Mask Set Errata 1

MC68HC12D60 Microcontroller Unit

This errata provides mask-set specific information applicable to the following MC68HC12D60 MCU mask set devices:

- 0K13J

Figure 2. Representation of unreliable start-up mode with slow crystal

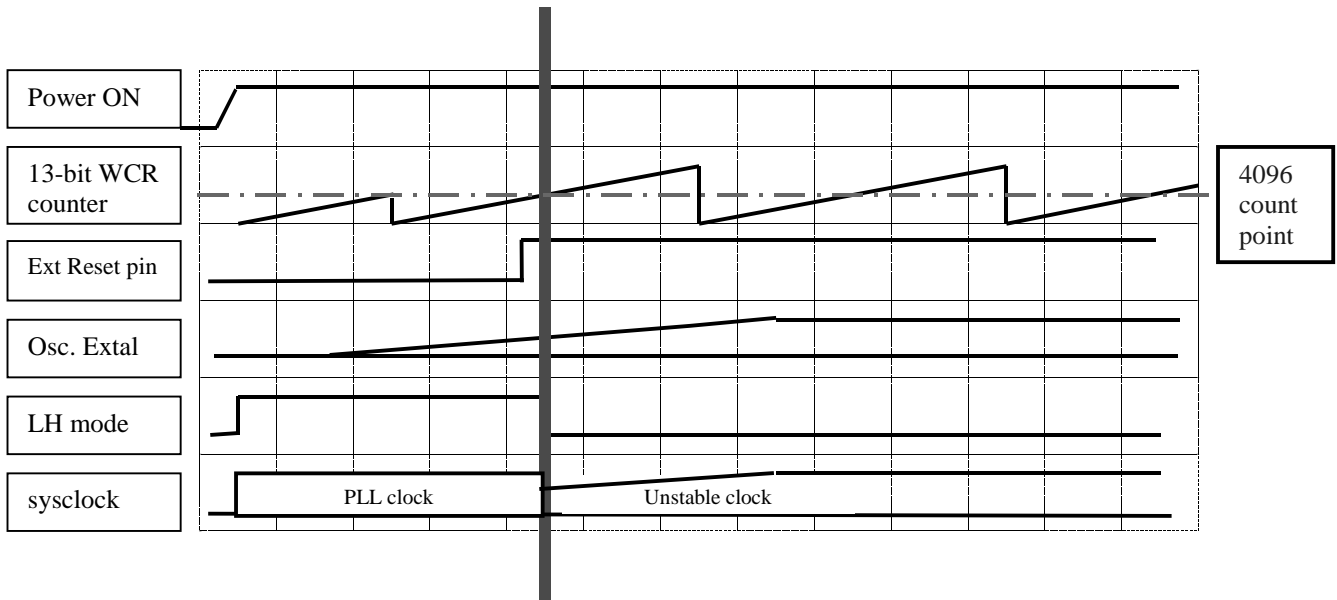
The HC12 mode of operation known as Limp-Home Mode (LHM) is enabled when the VDDPLL pin is at VDD and is entered if for any reason the external crystal ceases to oscillate. During this mode the CPU will be clocked from the free-running VCO clock of the PLL (at a nominal frequency of 1MHz). If LHM is enabled during the start-up phase (i.e. VDDPLL=5V, NOLHM bit=0) and the external RESET line is not held active until after the crystal frequency is stable then the device starts up in LHM since no crystal oscillations will be detected. This situation can arise with short reset periods and/or crystals that exhibit slow start-up characteristics.

For the first 4096 cycles i.e. during the internal reset period, Limp Home mode will be de-asserted if oscillator activity is detected by the clock monitor circuit -due to the asserted Reset signal there can be no CPU activity during the Reset phase. Following release of the external or internal POR RESET in LHM (which ever is later) the crystal oscillator is sampled by the clock monitor circuit after another 4096 VCO clock cycles and at intervals of 8192 clock cycles thereafter until the crystal is deemed to be operating. If the crystal oscillator is showing activity at the time it is checked then it will be deemed to be good, even though it may not have fully stabilized, and LHM will be de-asserted. This can cause the device to switch from LH mode to normal mode with the CPU clocked from an unstable signal from the crystal oscillator (see fig. 2) resulting in unpredictable function of the CPU.

Figure 3. Representation of preferred means of overcoming issue with Figure 2

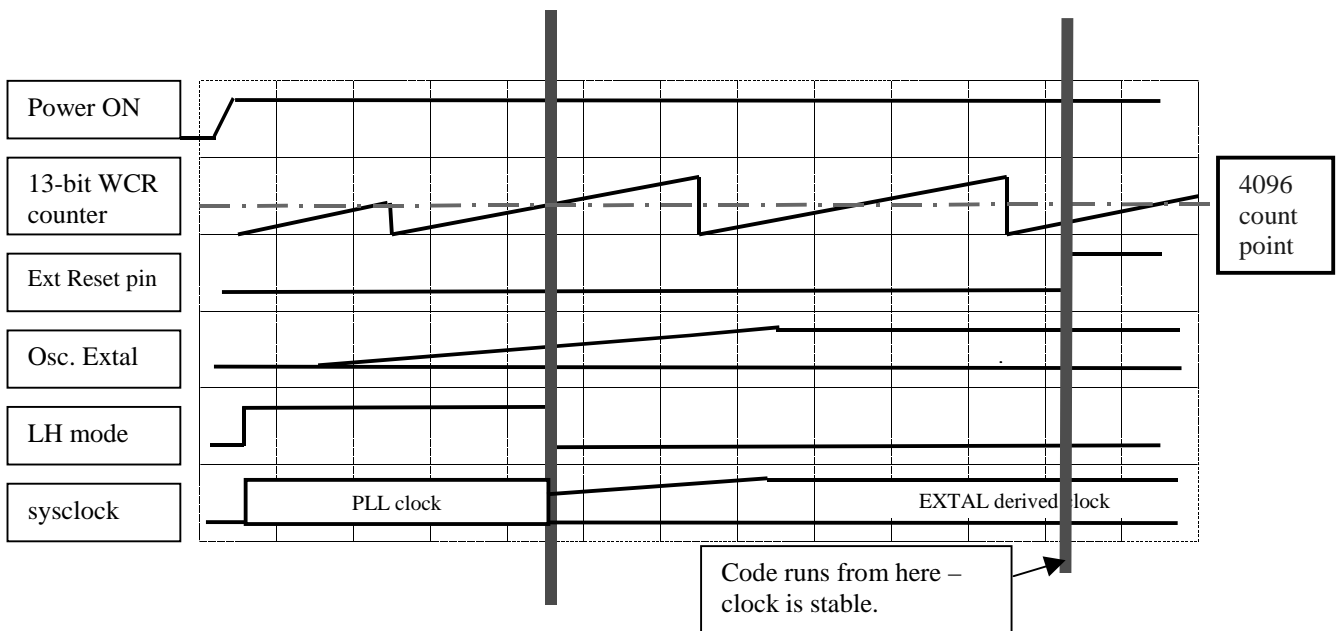
The Reset condition can be overcome by allowing the crystal oscillator circuit to stabilize before releasing the external RESET line (see fig. 3). Operation is similar to that shown in fig 2.

Lastly, an alternative and simpler approach is to just hold reset low for a substantial time (> 100 milliseconds) after Vdd has reached the operating voltage range.

In some applications it may be possible avoid this issue by delaying the connection of Vddpll to Vdd until the device has exited reset. This will sacrifice the limp home mode safety function upon startup, i.e. the part will no longer be able to start without a functioning crystal. A similar technique (disable PLL under software control) can be used to overcome the limitations of Stop mode.
